# UNITED STATES PATENT AND TRADEMARK OFFICE

10/564,226

<b>Office Action Summary</b>	<b>Application No.</b> 10/564,226	<b>Applicant(s)</b> THOEMMES, FRANZ	
	<b>Examiner</b> Jason J. Boeckmann	<b>Art Unit</b> 3752

## **DETAILED ACTION**

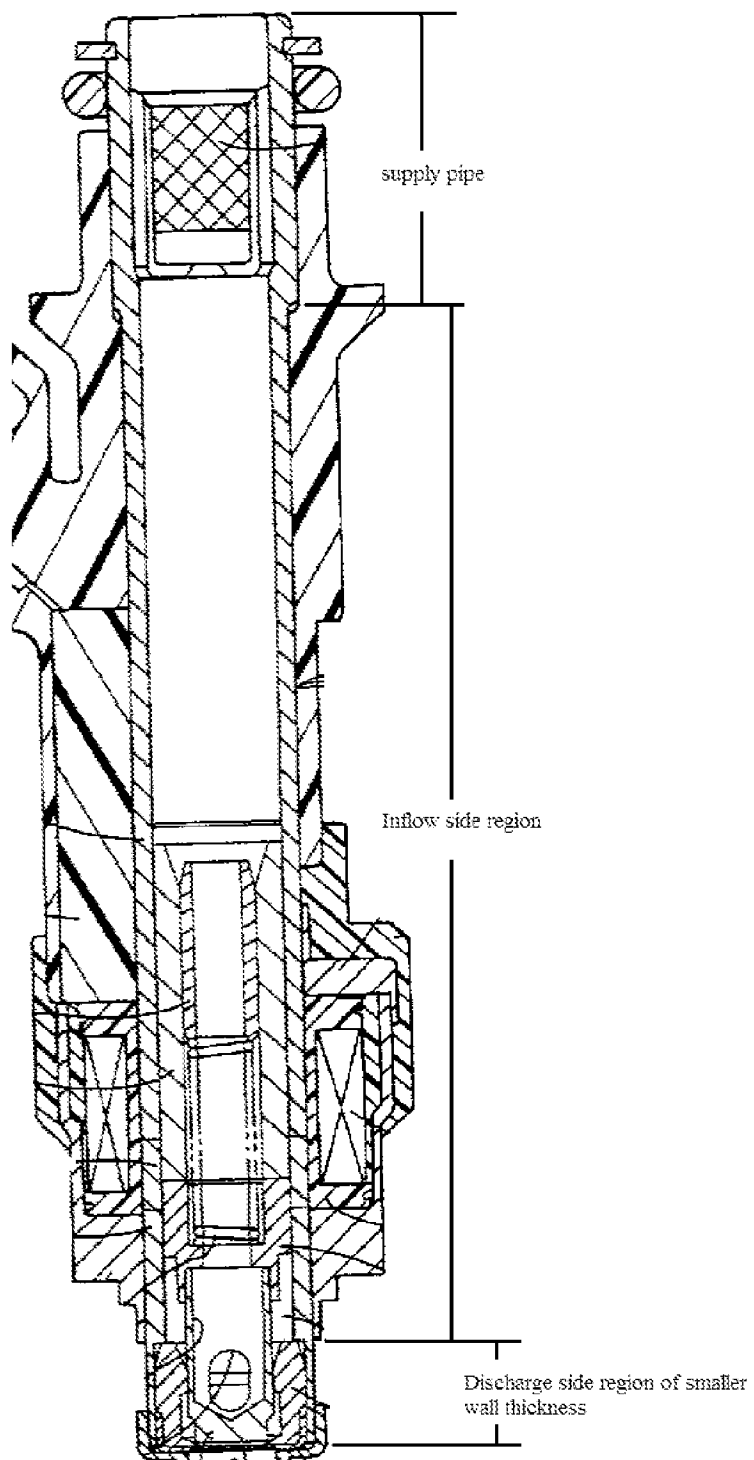
Claim 8 is rejected under 35 U.S.C. 102(e) as being anticipated by Aoki et al. (US 2002/0170987).

Aoki et al. shows a fuel injector (1) comprising; a valve needle (26) an armature (25) forming an axially movable valve port together with the valve needle, a restoring spring (24) acting upon the armature, a magnetic coil (31) cooperating with the armature, a valve-seat body (26), a valve closure member (28a) which forms a sealing seat with the valve seat body and; a valve sleeve (14) surrounding the armature and the valve needle, a wall thickness of the valve sleeve varying across its axial direction (fig

2), wherein the wall the wall thickness of the valve sleeve decreases in a discharge direction of a fuel (figure 2), wherein a radial cross section of the valve sleeve decreases between an inflow-side region and a discharge-side region on a color (figure 2), wherein the radial cross section and the wall thickness of the inflow-side region are constant from the collar to an inflow-side end of the valve sleeve (figure 2); wherein the decreased radial cross section and decreased wall thickness of the discharge-side region are constant from the collar to a discharge-side end of the valve sleeve (see examiners marked up figure below), and wherein the inflow side region of the valve sleeve is formed in one piece with a supply pipe (see examiners marked up figure below).

It is noted that the term "in order to limit noises emissions," of line 13, is being considered a functional limitation and is given little or no patentable weight in an apparatus claim.

Additionally, as to the recited process of forming the valve sleeve in one piece with a supply pipe, such is a product by process recitation. The patentability of a product does not depend on its method of production. If the product in the product-by-process claim is the same as or an obvious variant from a product in the prior art, the claim is unpatentable even though the prior product was made by a different process (see MPEP 2113).

Regarding claim 15, the fuel injector includes an intake pipe (8) that extends beyond the valve sleeve.
